PACIFIC GAS & ELECTRIC COMPANY

(Diablo Canyon Nuclear Power Plant, Units 1
and 2)

ORDER

LIMITED APPEARANCE STATEMENT OF DR. VICTOR GILINSKY

FIGURE NO. 4-23

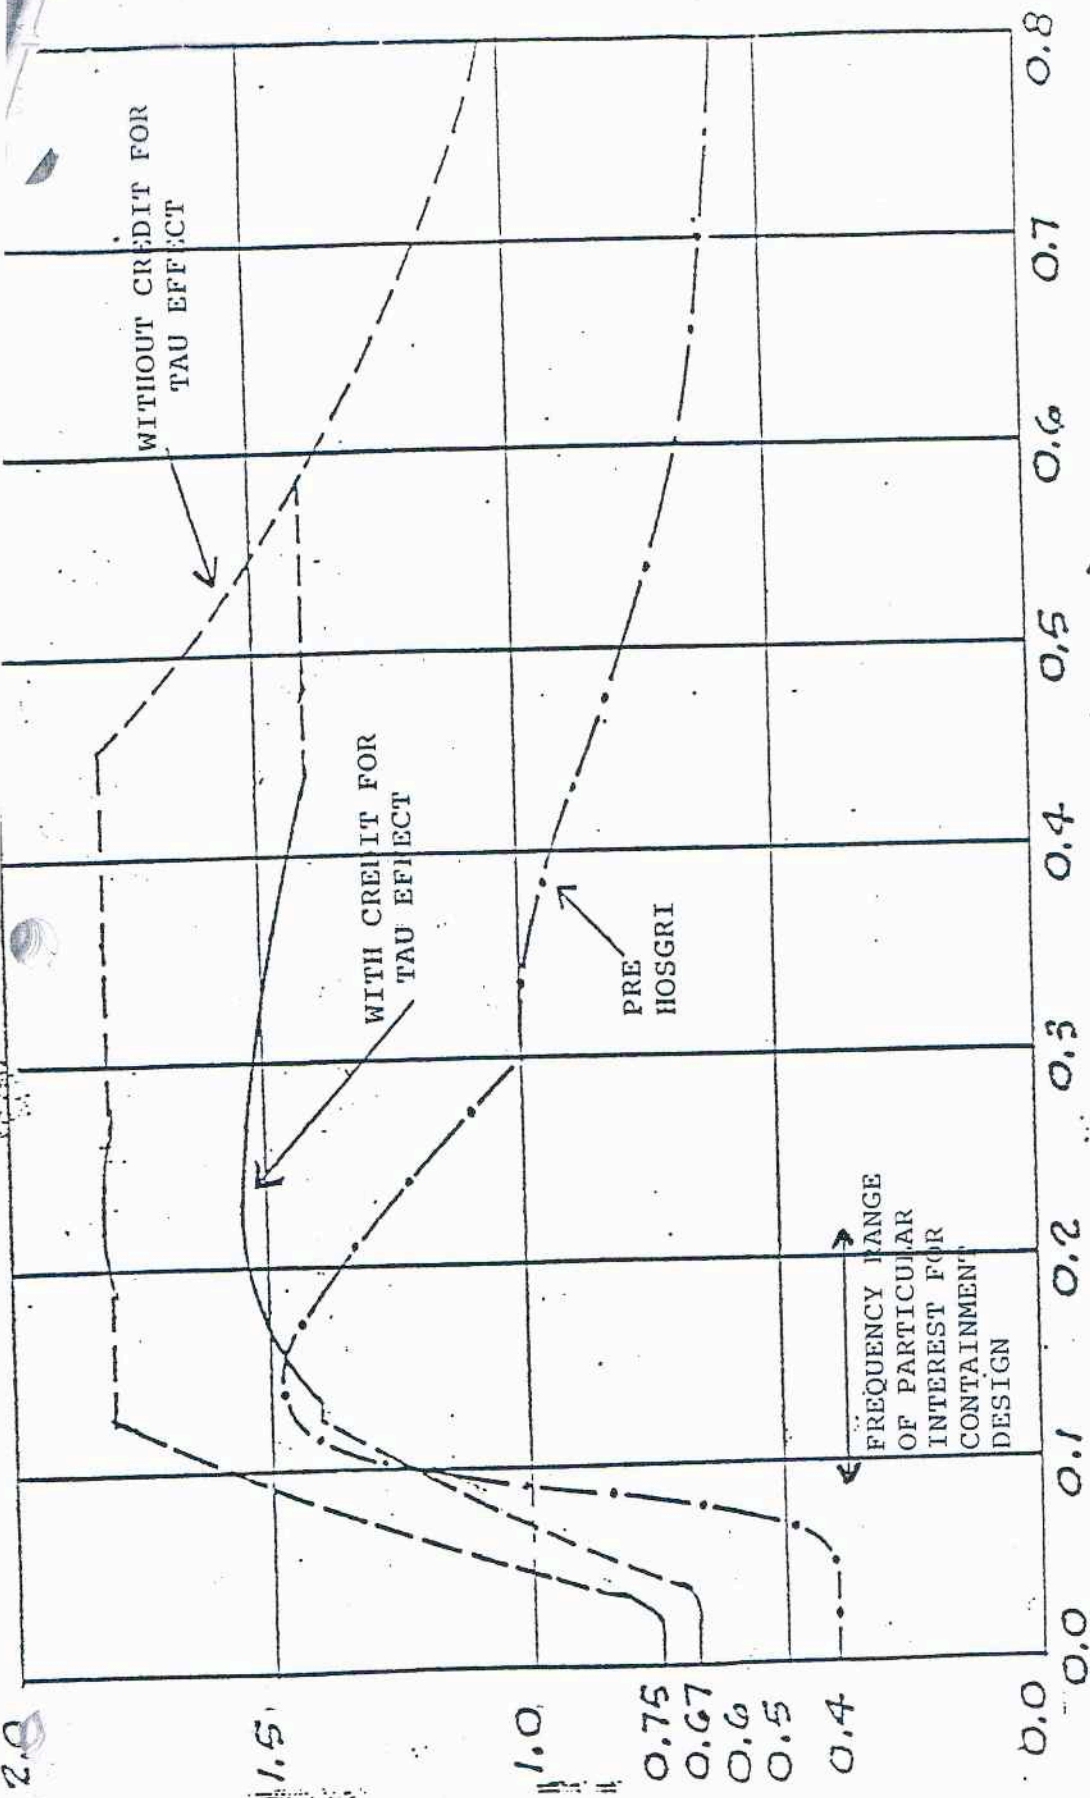
With the changes and adjustments permitted by the Board it turns out that the post-Hosgri seismic response spectrum does not in all respects represent a more severe seismic standard than the one used before the discovery of the Hosgri fault. As the accompanying diagram illustrates, in the frequency range between 5 and 10 hertz (cycles per second), a range of particular interest in the analysis of the containment building surrounding the reactor, the two response spectra are quite close.¹⁰ For part of this range, in fact, the old spectrum shows a higher response. In other words, for that part of the range the original design conditions were more demanding than the new ones imposed after the discovery of the Hosgri fault. This new

spectrum is the basis of the engineering reanalysis and ultimately determined the extent to which the containment was to be modified. Not surprisingly, in view of the above, only minor changes were required in this area.
